**RE: National Construction Code (NCC) 2022 Amendment 2 Volume
One Section J Part J4 Statement of Compliance**

JOB NO.: 240516

SUBJECT PREMISE: Opal Bayview Gardens | Annam Road Bayview, NSW 2104

Attachment B – Building Fabric Requirements Markups

A100 BASEMENT
SCALE: 1:200
0 5.0M 10.0M

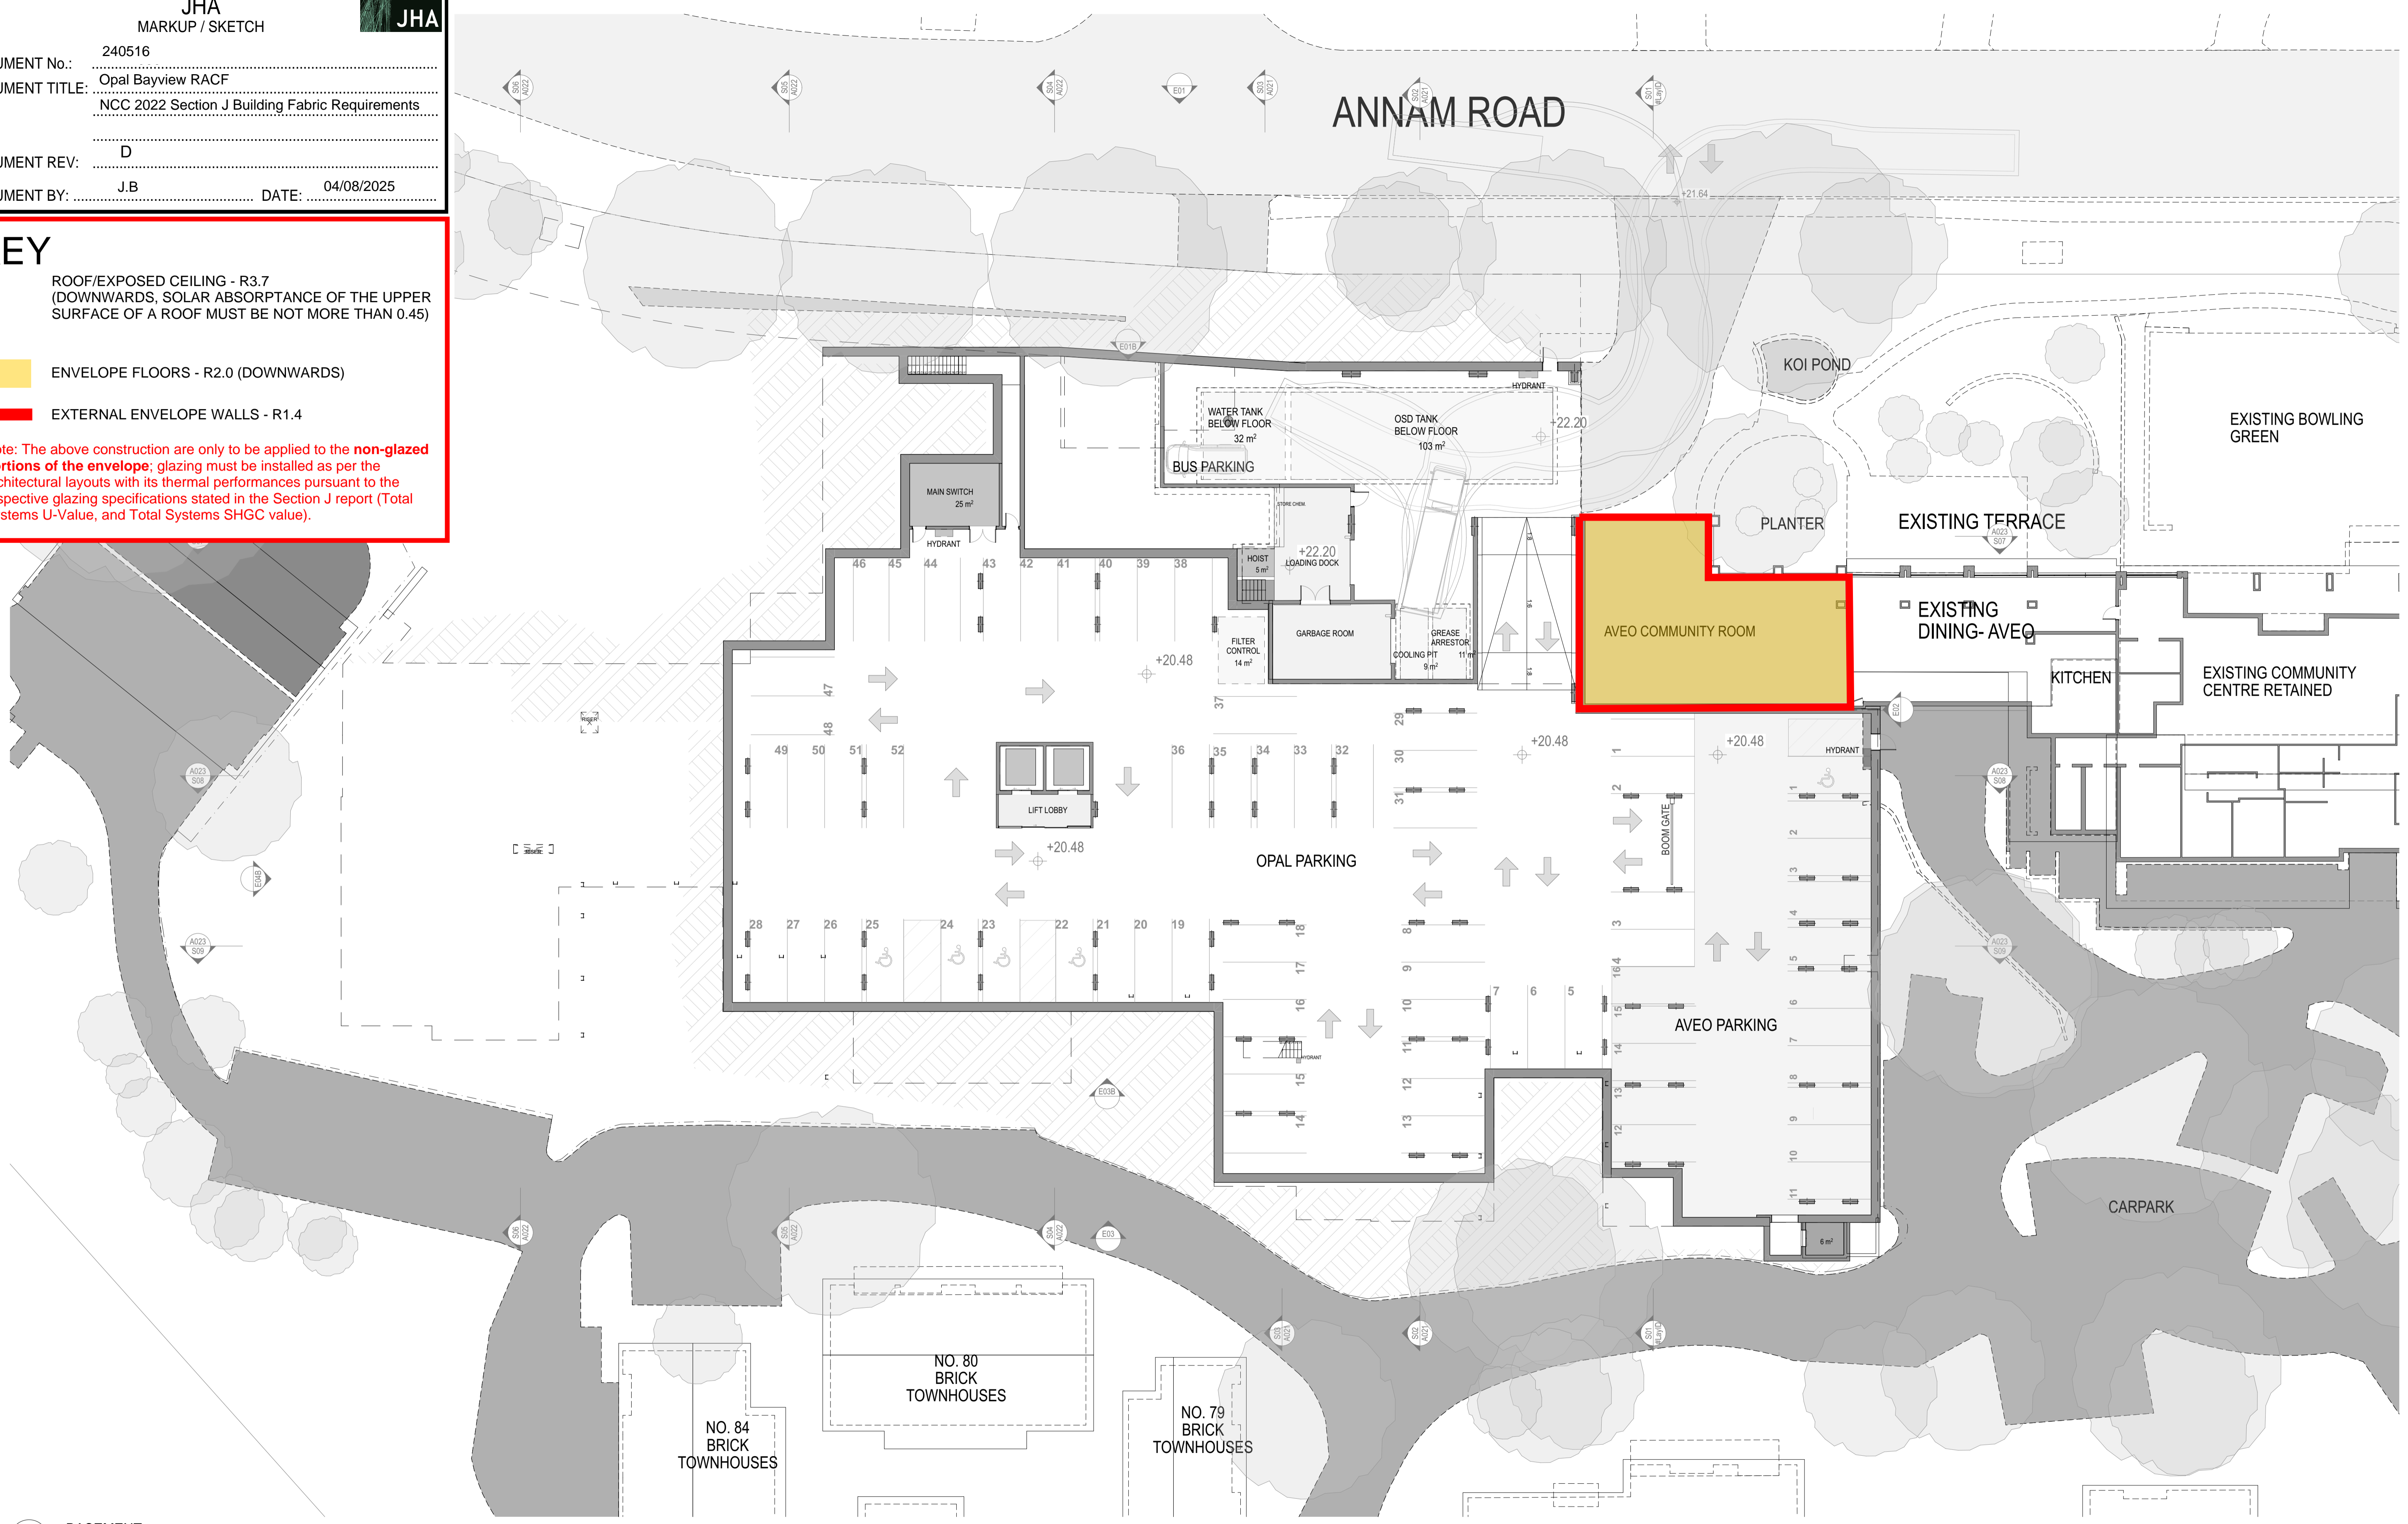
KEY
ROOF/EXPOSED CEILING - R3.7
(DOWNWARDS, SOLAR ABSORPTANCE OF THE UPPER SURFACE OF A ROOF MUST BE NOT MORE THAN 0.45)
ENVELOPE FLOORS - R2.0 (DOWNWARDS)
EXTERNAL ENVELOPE WALLS - R1.4
Note: The above construction are only to be applied to the non-glazed portions of the envelope; glazing must be installed as per the architectural layouts with its thermal performances pursuant to the respective glazing specifications stated in the Section J report (Total Systems U-Value, and Total Systems SHGC value).

A101 LOWER GROUND FLOOR
SCALE: 1:200

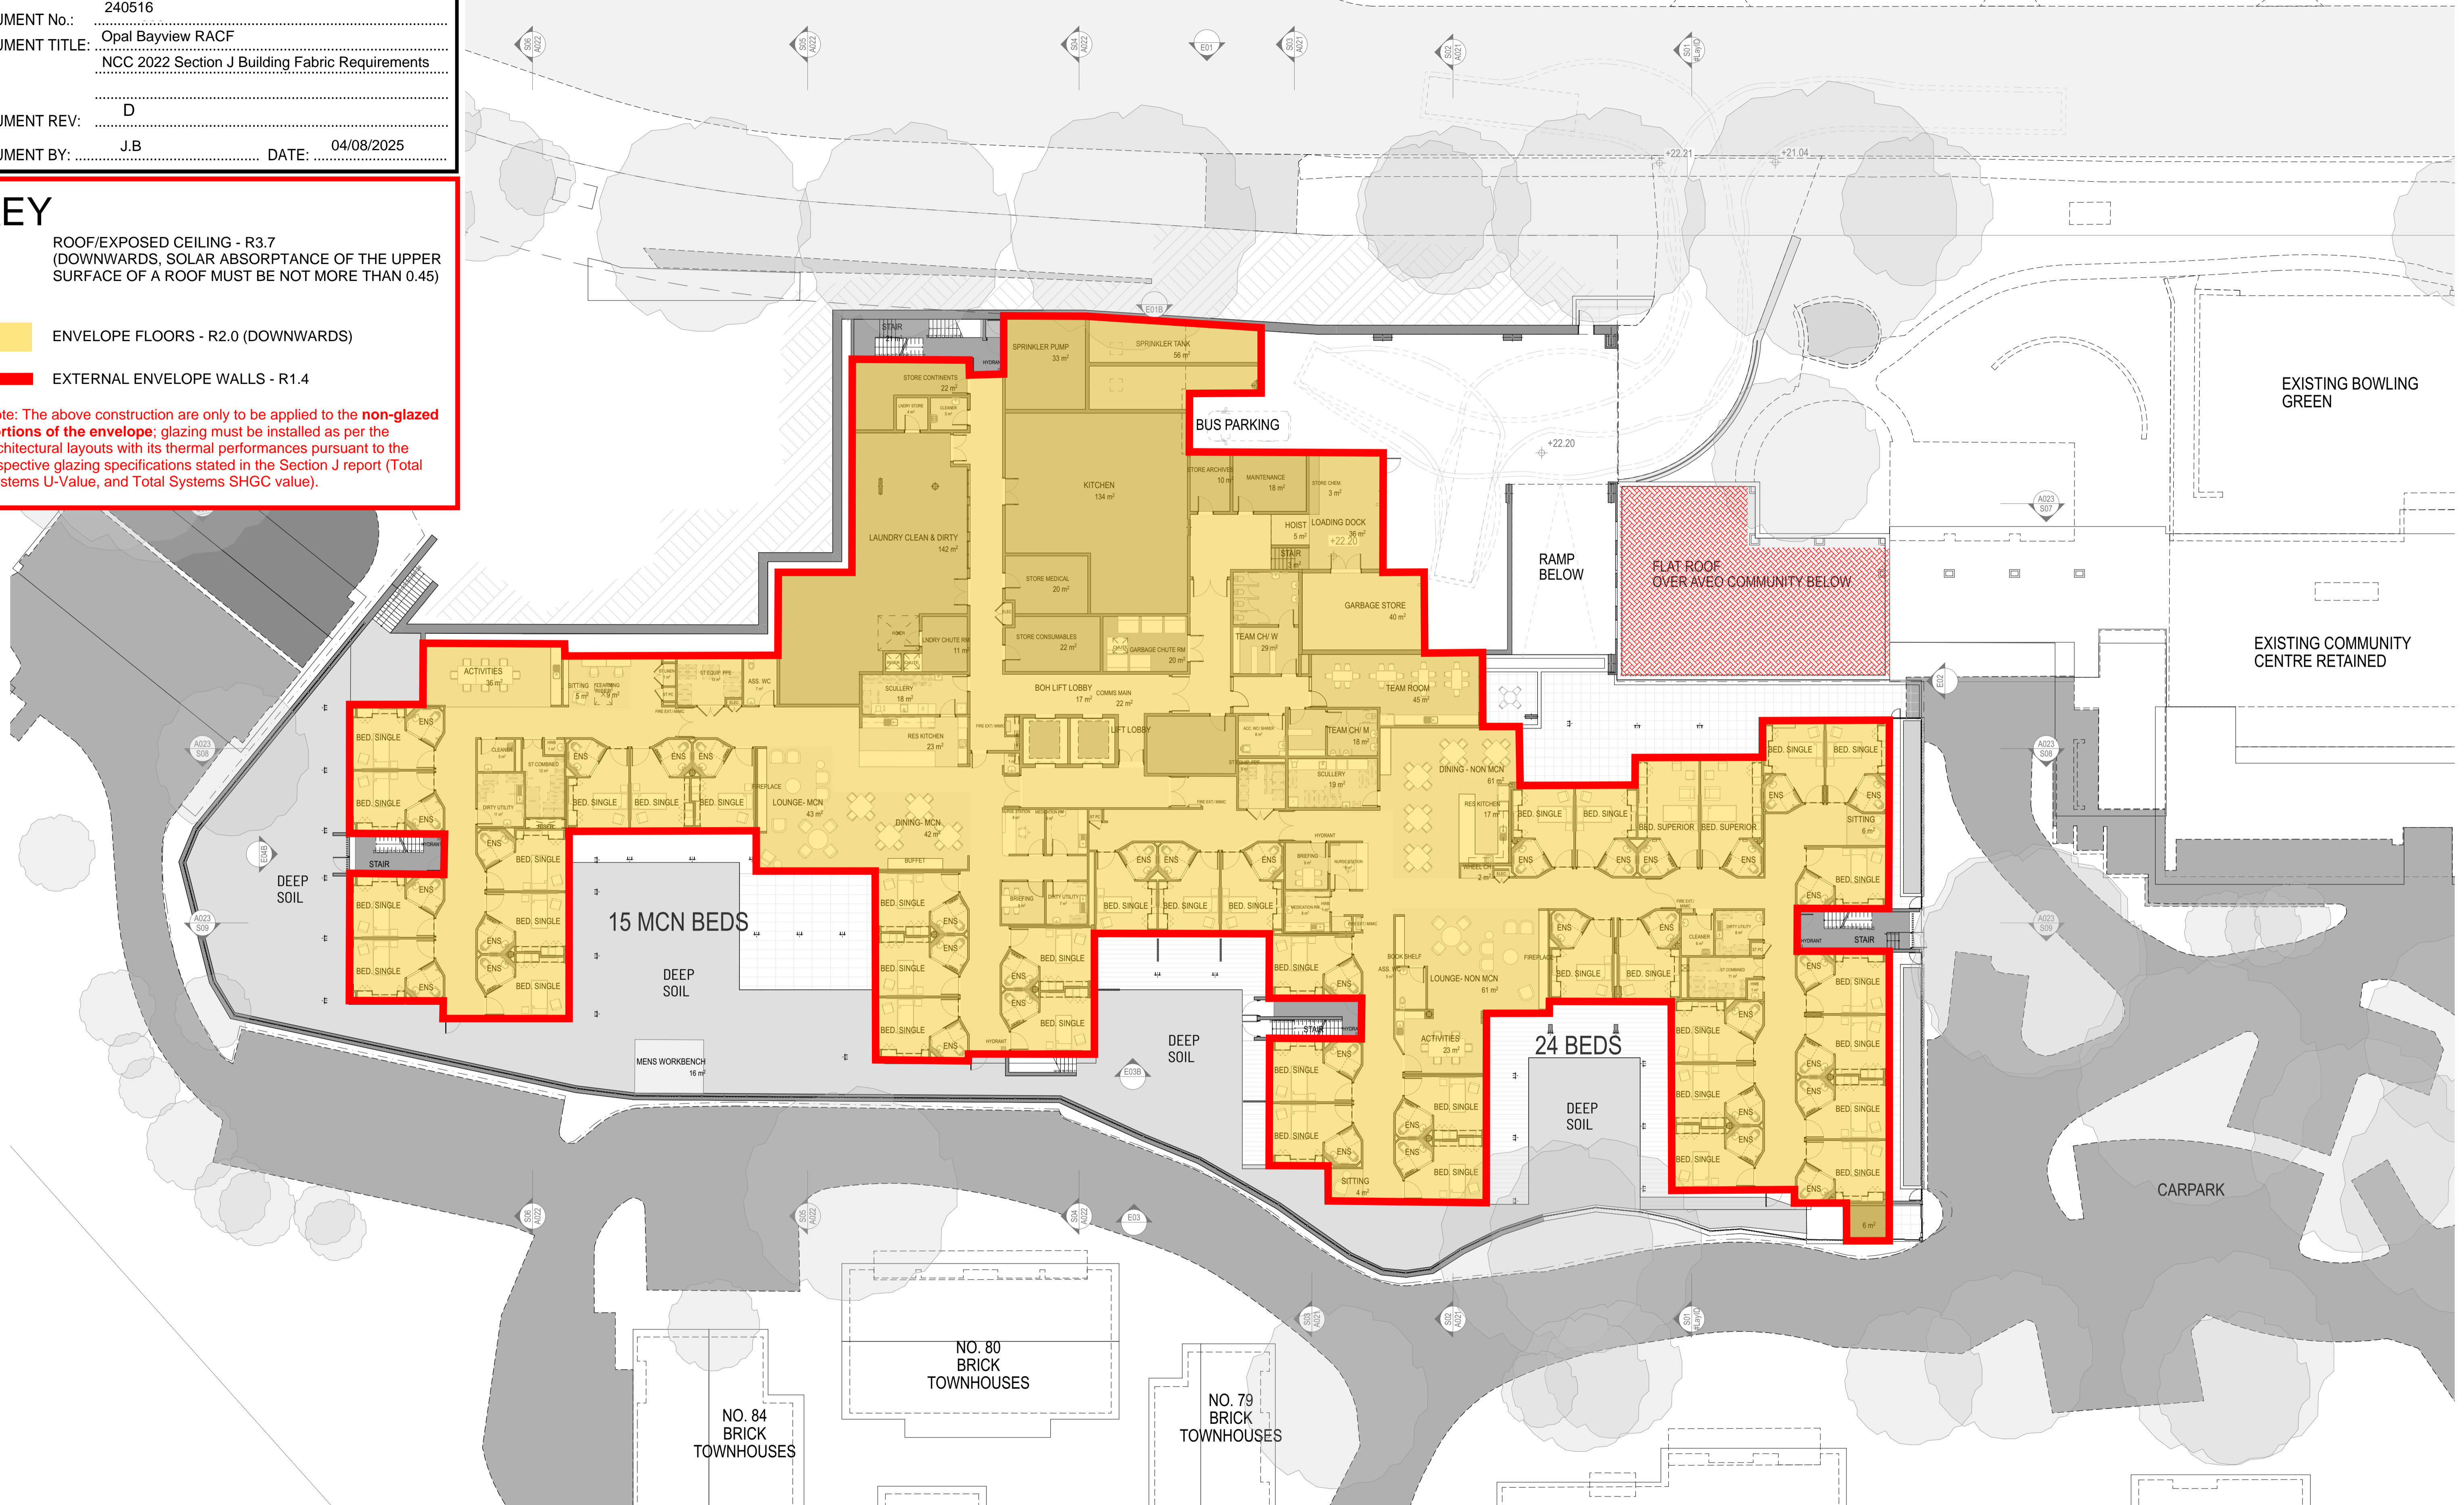
ROOF/EXPOSED CEILING - R3.7
(DOWNWARDS, SOLAR ABSORPTANCE OF THE UPPER SURFACE OF A ROOF MUST BE NOT MORE THAN 0.45)

ENVELOPE FLOORS - R2.0 (DOWNWARDS)

EXTERNAL ENVELOPE WALLS - R1.4

Note: The above construction are only to be applied to the **non-glazed portions of the envelope**; glazing must be installed as per the architectural layouts with its thermal performances pursuant to the respective glazing specifications stated in the Section J report (Total Systems U-Value, and Total Systems SHGC value).
